Metropolitan Planning Commission

Staff Reports

June 26, 2008

Site Plan

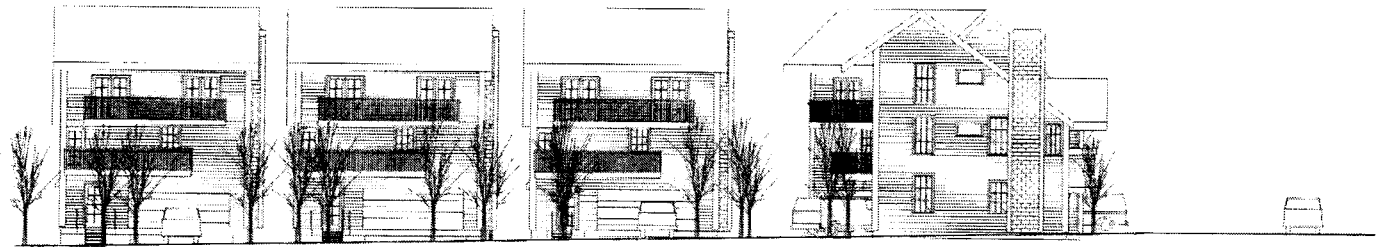
The proposed site plan calls for 5 single-family detached units with a density of approximately 13 units per acre. Units have shallow front setbacks and are oriented towards Garfield Street and 7th Avenue, North. Three units front on Garfield Street and one unit fronts on 7th Avenue, North. The remaining unit is situated at the corner and is oriented towards both streets.

Access is proposed from the alley and no other vehicular access is proposed. Each unit would have a two car garage and additional parking spaces directly behind each garage. The plan also identifies 11 additional parallel parking spaces along the southern property line for a total of 31 on-site parking spaces. On-street parking is also permitted along Garfield and 7th Avenue, North.

The proposed plan is not consistent with the area's land use policies. The policies call for mixed-housing and are intended to promote a dense mixture of housing types along Garfield Street. Even though the policies are intended to promote a variety of housing types, single-family detached housing can also be appropriate if the layout and design foster an urban streetscape and are not out of character with the surrounding area.

While the proposed use can meet the intent of the policies the layout and design of the plan do not. The site plan includes units that are identical in appearance and a corner unit that is angled towards the intersection rather than addressing Garfield and 7th Avenue. The identical houses are not consistent with the diversity of housing in this area. In addition, the corner unit should wrap the corner to address both Garfield Street and 7th Avenue North in a way that creates a strong edge along both streets.

Rather than design homes that specifically address the context of this property, the applicant has simply duplicated the same house plan for each unit. The inappropriate housing product has forced the applicant to turn the corner unit at a 45-degree angle because turning the house to front on both streets would block access to the rear garage. The applicant should submit a revised plan that includes homes that are designed for this property, including a corner unit that addresses each street with an appropriate street frontage.

The plan lacks specific details regarding exterior building materials. Proposed building materials should be clearly indicated on the plan and should not include vinyl siding or exposed cinder block. The ground floor should be elevated and not be a slab on grade. The first floor should be elevated at a minimum 18" from finished grade. Elevation of the first floor of housing is essential to reflect the urban context of this location.

1. Provide a product that is designed for the site. Corner unit should wrap the corner providing a strong edge along both Garfield Street and 7th Avenue North.
2. First floor shall not be slab on grade and shall be raised a minimum of 18" from the finished grade.
3. Identify exterior building materials. No vinyl siding or exposed cinder block shall be allowed.
4. Any front second floor porch balcony shall be designed in a way that opens it up and is contextually appropriate with other balconies in the

5. Provide adequate site data table. Table shall include information such as proposed FAR, ISR, density, parking, open space and all other relevant information.

6. Identify existing ROW and provide additional ROW along Garfield Street as needed to meet the cross section called out in the Detailed Neighborhood Design Plan.

7. Provide 6' wide sidewalk and 6' wide planting strip.
8. Remove all notes pertaining to 2006SP-119U-08.
9. All parking, utilities, meter boxes, back flow preventers, heating and cooling units and other mechanical systems shall be screened to a minimum height of 3 feet, or located away from public view.

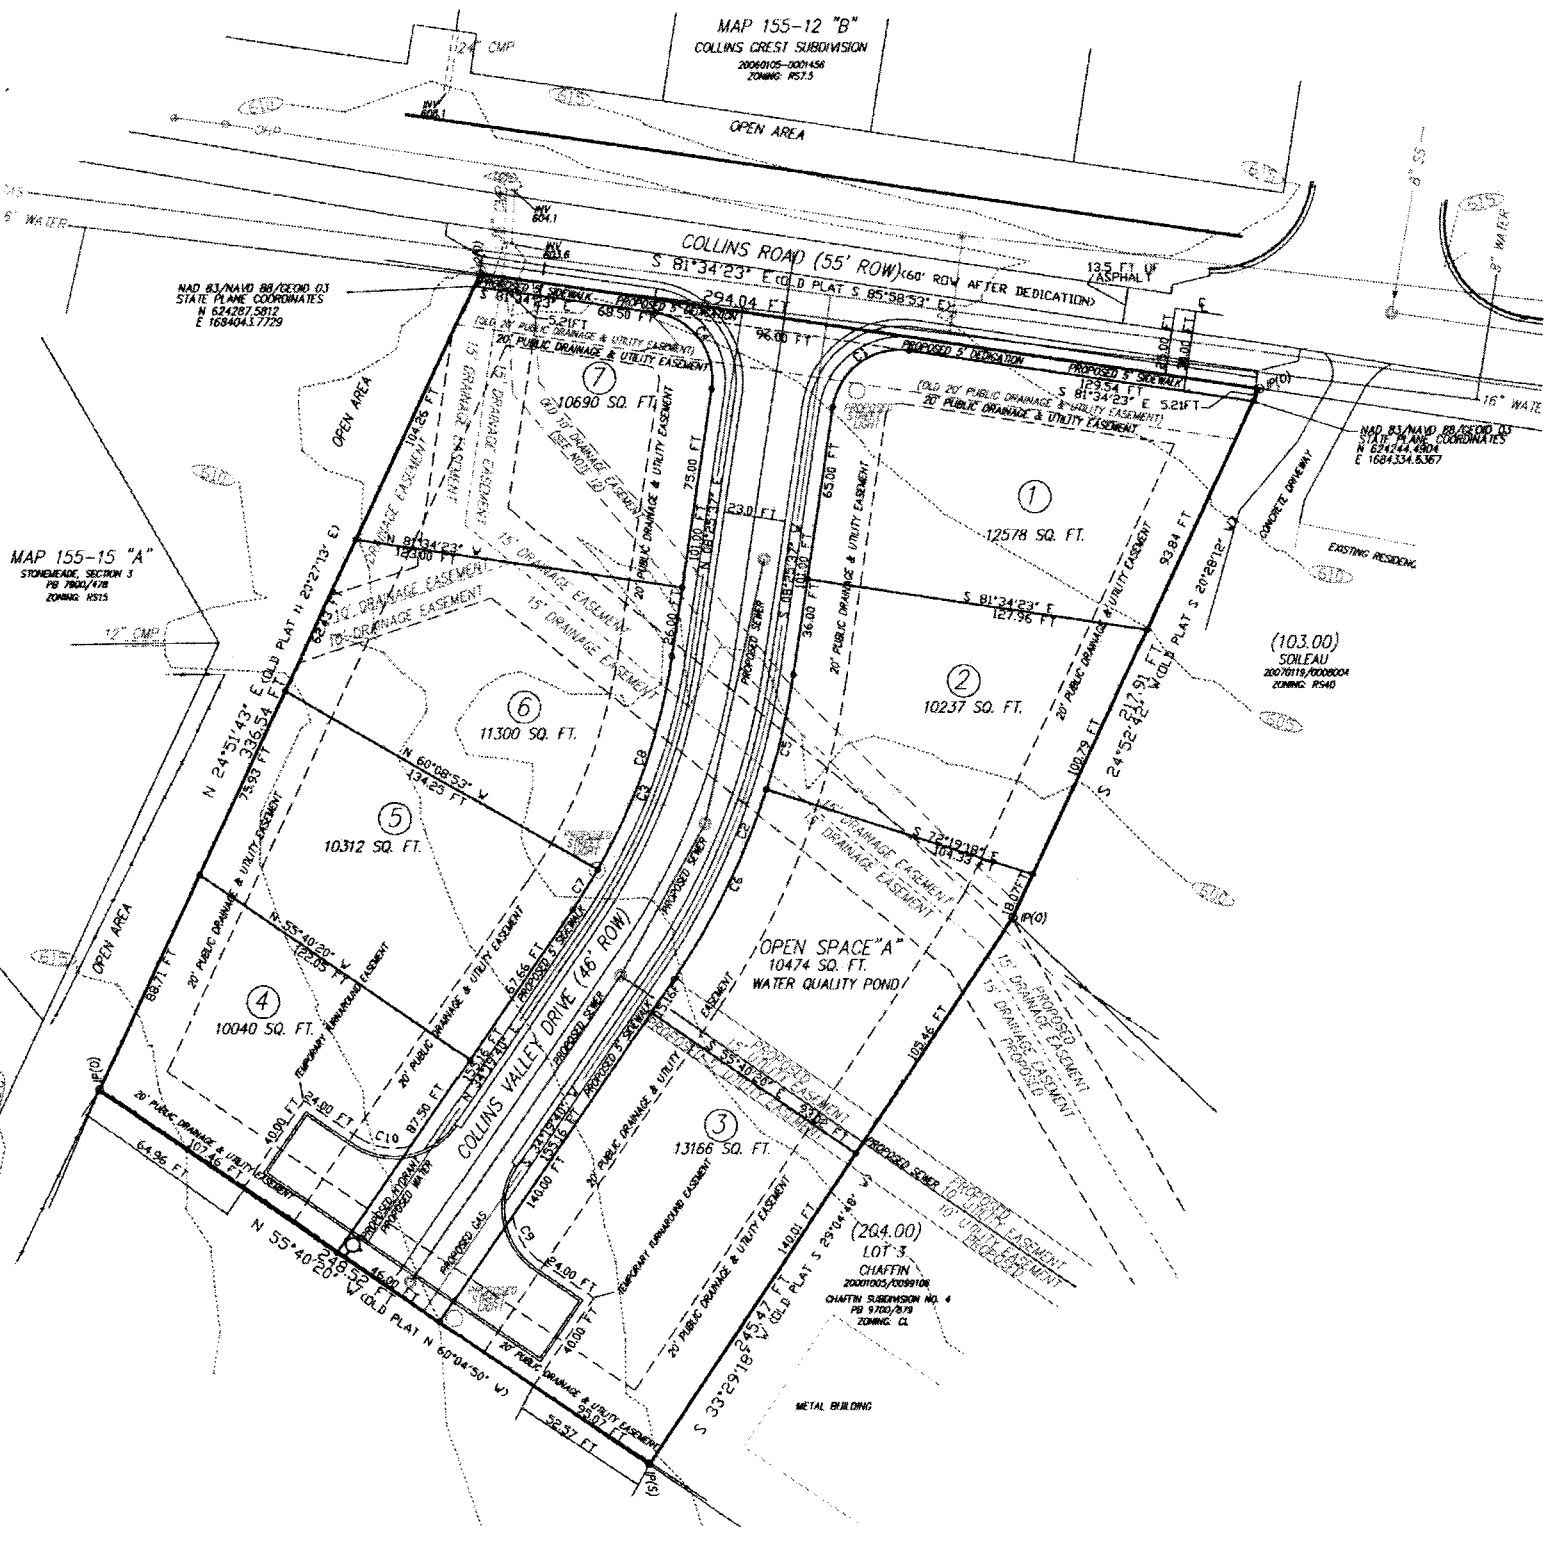
- One & two family final plat plans must show results from fire hydrant(s) flow test, performed within 6 months with a minimum of 1000 gpm @ 20 psi available at hydrants, for buildings up to 3600sq. ft. to be approved for fire hydrant flow requirements.

- Developer to provide construction drawings and a digital .dwg file @ state plane coordinates (TN83F) that contains the civil site information (approved by Metro Planning w/ any changes from other departments)
- Developer drawing should show any and all existing utilities easements on property.
- 20-foot easement required adjacent to all public rights of way **and 20' PUE centered on all NES conduits. (Developer may consider recording all open space as a PUE).**
- NES can meet with developer/engineer upon request to determine electrical service options

- NES needs any drawings that will cover any road improvements that Metro PW might require
- NES follows the National Fire Protection Association rules; Refer to NFPA 70 article 450-27; and NESC Section 15 - 152.A.2 for complete rules
- NES needs load information and future plans or options to buy other property (over all plans).
- Developer to provide high voltage layout for underground conduit system and proposed transformer locations for NES review and approval
- Any 3 phase load in any of the phases?
- Does developer have options on property next to this parcel?

1. Fire Marshal requirements shall be met prior to final plat approval.
2. Public Works requirements shall be bonded or completed prior to final plat recordation.
3. Pursuant to 2-3.4.e of the Metro Subdivision Regulations, because this application has received conditional approval from the Planning Commission, that approval shall expire unless revised plans showing the conditions on the face of the plans are submitted prior to any application for a final plat, and in no event more than 30 days after the date of conditional approval by the Planning Commission.
